Value Engineering Study

KY 15 - KY 28 to HADDIX

Item #10-285.00 and #10-286.00

Kentucky Transportation Cabinet (KTC)

PROPOSAL 1
FIGURE 1

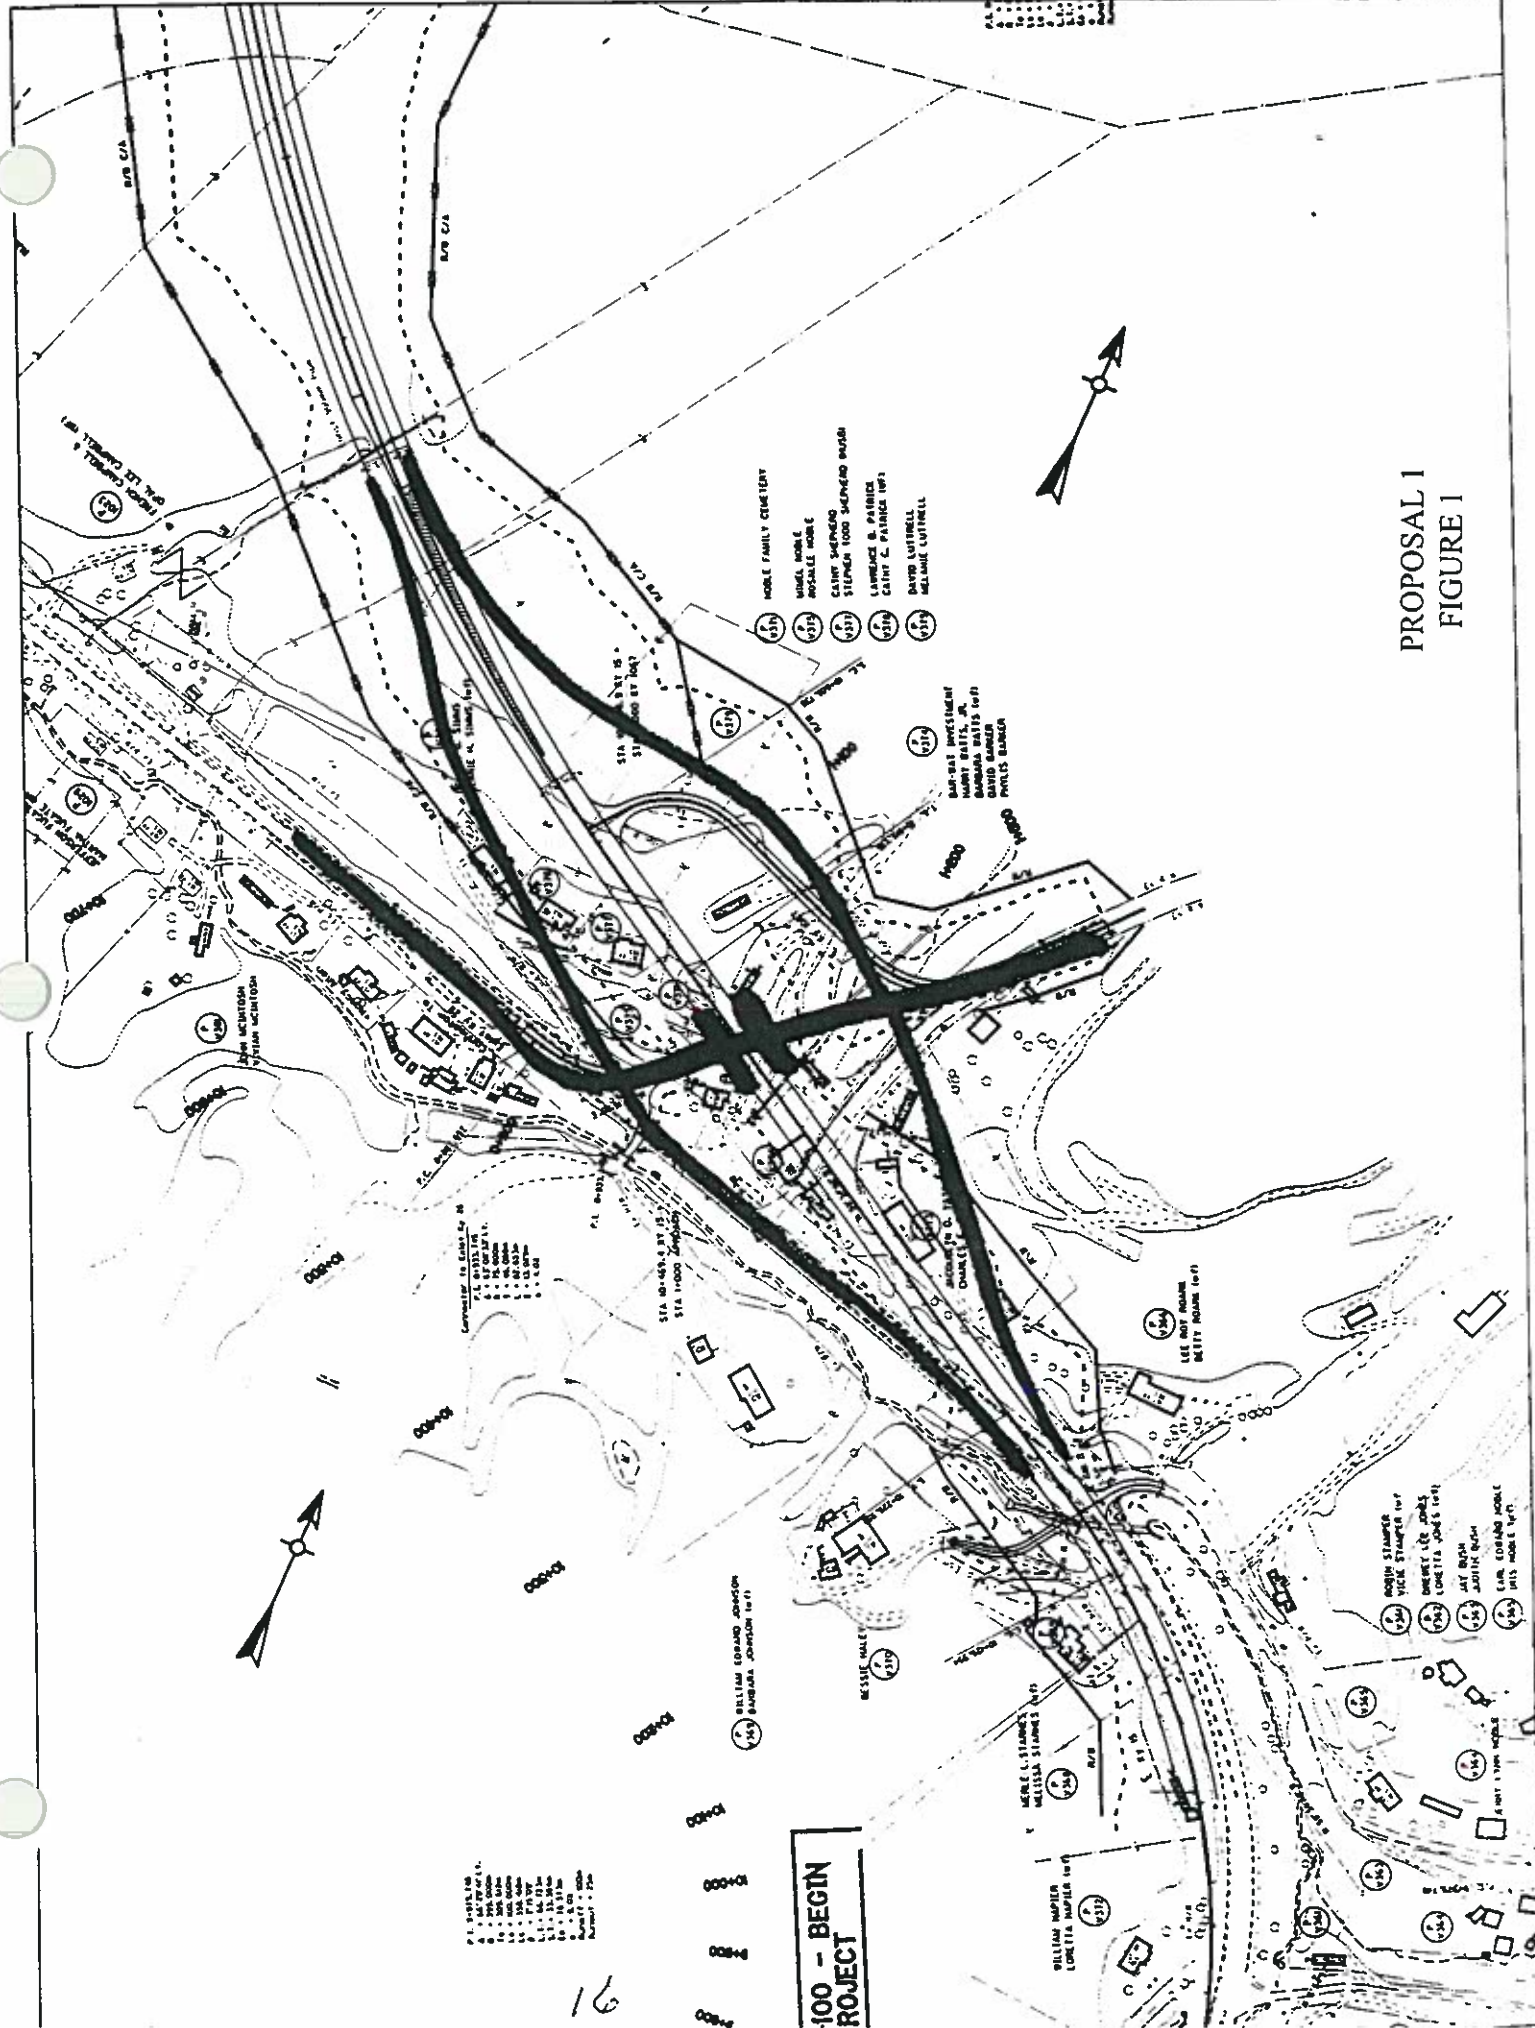
Area 1: Raising the grades in this area requires the modification of the at-grade intersection at approximate Station 10+500 to a separated-grade diamond intersection(see Figure 1). The at-grade intersection at Station 12+100 would be closed on the left and the approach to the right would have to be relocated. Following table summarizes an approximate vertical alignment. The final vertical alignment requires further study and evaluation.
